Project	<b>IEEE 802.16 Broadband Wireless Access Working Group</b> < <a href="http://ieee802.org/16">http://ieee802.org/16</a> >	
Title	<b>Proposal on change in ARQ</b>	
Date Submitted	<b>2003-09-09</b>	
Source(s)	Vladimir Yanover Tal Kaitz Naftali Chayat Marianna Goldhammer Lei Wang Ofar Kelman Radu Selea Robert Nelson Roger Eline Baraa Al Dabagh Itzik Kitroser	Alvarion <a href="mailto:vladimir.yanover@alvarion.com">mailto:vladimir.yanover@alvarion.com</a> Alvarion <a href="mailto:tal.kaitz@alvarion.com">tal.kaitz@alvarion.com</a> Alvarion <a href="mailto:naftali.chayat@alvarion.com">naftali.chayat@alvarion.com</a> Alvarion <a href="mailto:marianna.goldhammer@alvarion.com">marianna.goldhammer@alvarion.com</a> Wi-Lan <a href="mailto:LeiW@Wi-LAN.com">LeiW@Wi-LAN.com</a> Airspan <a href="mailto:okelman@Airspan.com">okelman@Airspan.com</a> Redline Comm. <a href="mailto:Radu@redlinecommunications.com">Radu@redlinecommunications.com</a> MacPhyModems <a href="mailto:bob_nelson@ieee.org">bob_nelson@ieee.org</a> Intel <a href="mailto:roger.j.eline@intel.com">roger.j.eline@intel.com</a> Intel <a href="mailto:baraa.al.dabagh@intel.com">baraa.al.dabagh@intel.com</a> Runcom <a href="mailto:itz

Figure 34: Transmitter ARQ state machine

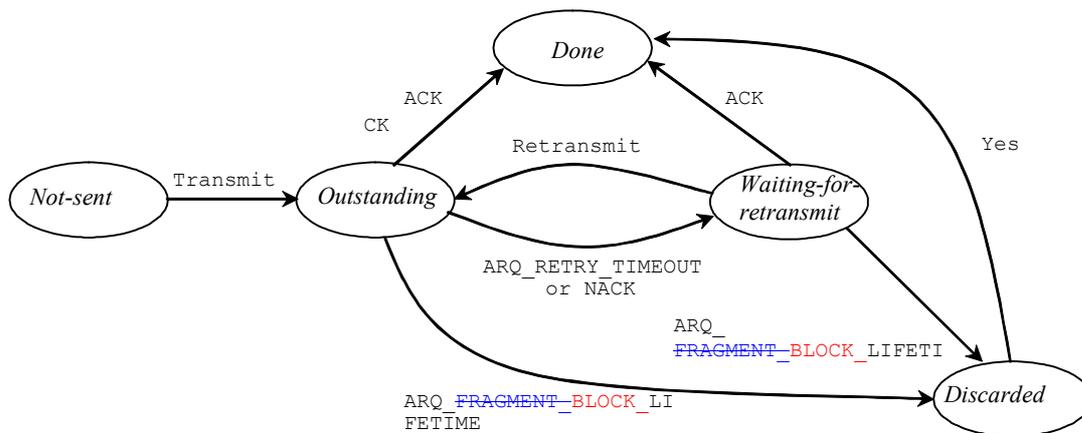
~~The transmitter is responsible for choosing the appropriate fragment size on a per fragment basis. Determining fragment size is outside the scope of this standard. Unlike non-ARQ connections, where a single MAC PDU would not normally have two consecutive fragments from the same MAC SDU, this is likely for ARQ-enabled connections, since such fragmentation can facilitate retransmission. The MAC SDU fragment structure shall be maintained for retransmissions~~ An ARQ ~~fragment~~ block may be in one of the following four states, not-sent, outstanding, discarded and waiting-for-retransmission. Any ARQ ~~fragment~~ block begins as not-sent. After it is sent it becomes outstanding for a period of time termed ACK\_RETRY\_TIMEOUT. While a ~~fragment~~ block is in outstanding state, it either is acknowledged and discarded, or transitions to waiting-for-retransmission after ACK\_RETRY\_TIMEOUT or NACK. An ARQ ~~fragment~~ block can become waiting-for-retransmission before the ACK\_RETRY\_TIMEOUT period expires if it is negatively acknowledged. An ARQ ~~fragment~~ block may also change from waiting-for-retransmission to discarded when an ACK message for it is received or after a timeout ARQ\_FRAGMENT\_LIFETIME. For a given connection the transmitter shall first handle (transmit or discard) ~~fragment~~ block in 'waiting-for-retransmission' state and only then ~~fragment~~ block in 'non-sent' state. ~~Fragments~~ Blocks in 'outstanding' or 'discarded' state shall not be transmitted. When

fragments blocks are retransmitted, the fragment with the lowest FSN BSN shall be retransmitted first. The ARQ transmit fragment block state sequence is shown in Figure 34.

**Figure 37 - ARQ fragment block reception**

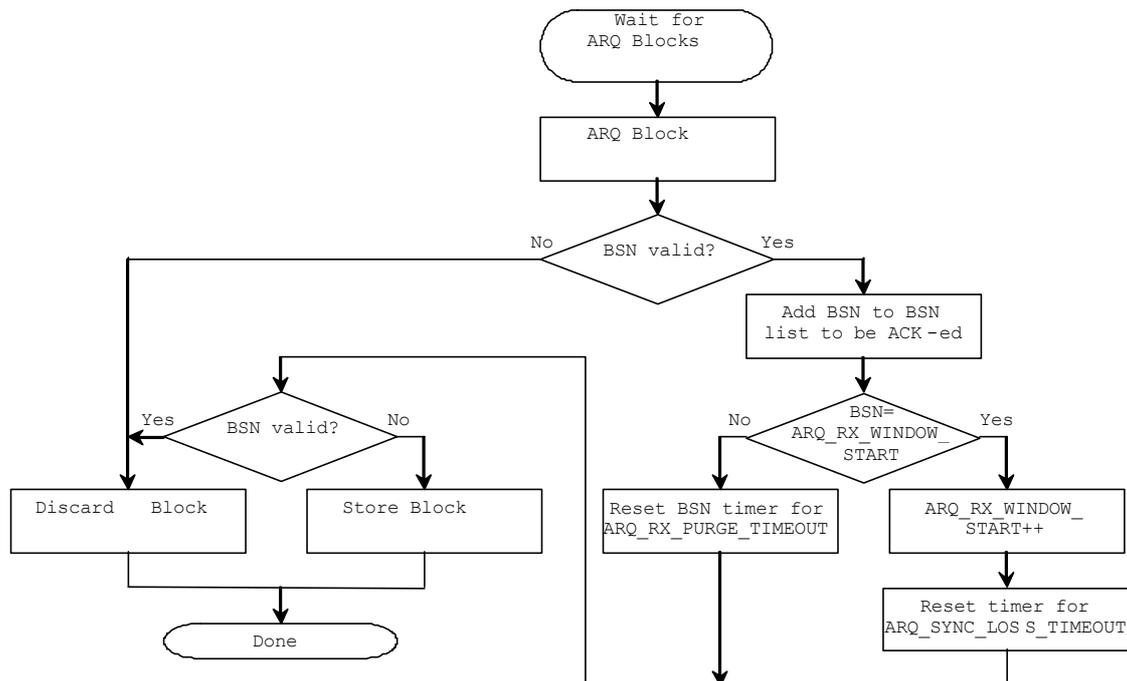
When a PDU is received, its integrity is determined based on the CRC-32 checksum. If a PDU passes the checksum, it is unpacked and de-fragmented, if necessary. The receiver maintains a sliding-window defined by ARQ\_RX\_WINDOW\_START state variable and the ARQ\_WINDOW\_SIZE parameter. When an ARQ fragment block with a number that falls in the range defined by the sliding window is received, the receiver shall accept it. ARQ fragment block numbers outside the sliding window shall be rejected as out of order. The

receiver should discard duplicate ARQ **fragments blocks** (i.e. ARQ **fragments blocks** that were already received correctly) within the window.
